UNITED STATES PATENT AND TRADEMARK OFFICE

APPLICATION NO.	FILING DATE	FIRST NAMED INVENTOR	ATTORNEY DOCKET NO.	CONFIRMATION NO.
10/549,564	06/26/2006	Thomas McGee	102790-147 (30085 US)	4683
27389 7590 11/13/2008 NORRIS, MCLAUGHLIN & MARCUS 875 THIRD AVE 18TH FLOOR NEW YORK, NY 10022			EXAMINER SHARPE, DANIEL T	
			ART UNIT 3752	PAPER NUMBER
			MAIL DATE 11/13/2008	DELIVERY MODE PAPER

Office Action Summary	Application No. 10/549,564	Applicant(s) MCGEE ET AL.	
	Examiner DANIEL T. SHARPE	Art Unit 3752

DETAILED ACTION

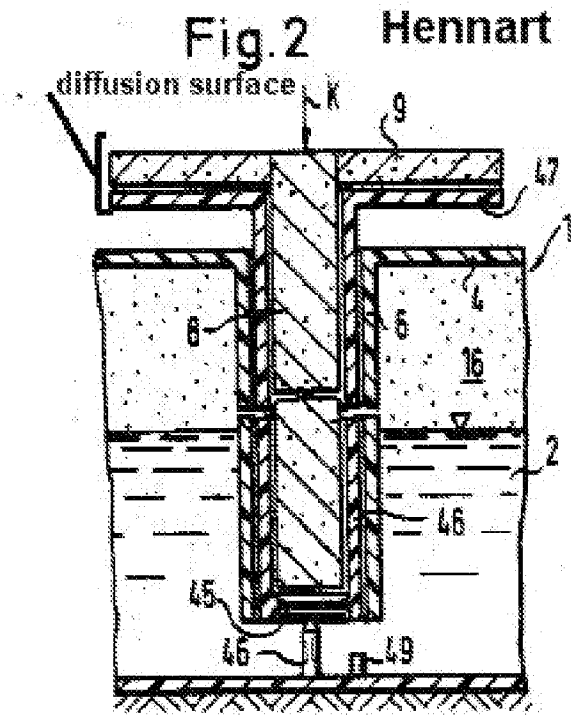
Regarding claims 1 and 9: Hennart discloses a reservoir(1) containing a volatile liquid material, a rod-like transfer member(8), at least one diffusion surface (see examiner generated figure below) extending essentially laterally from the transfer member and comprising at least one non-integral, nonporous sheet(47) bearing a surface capillarity(9).
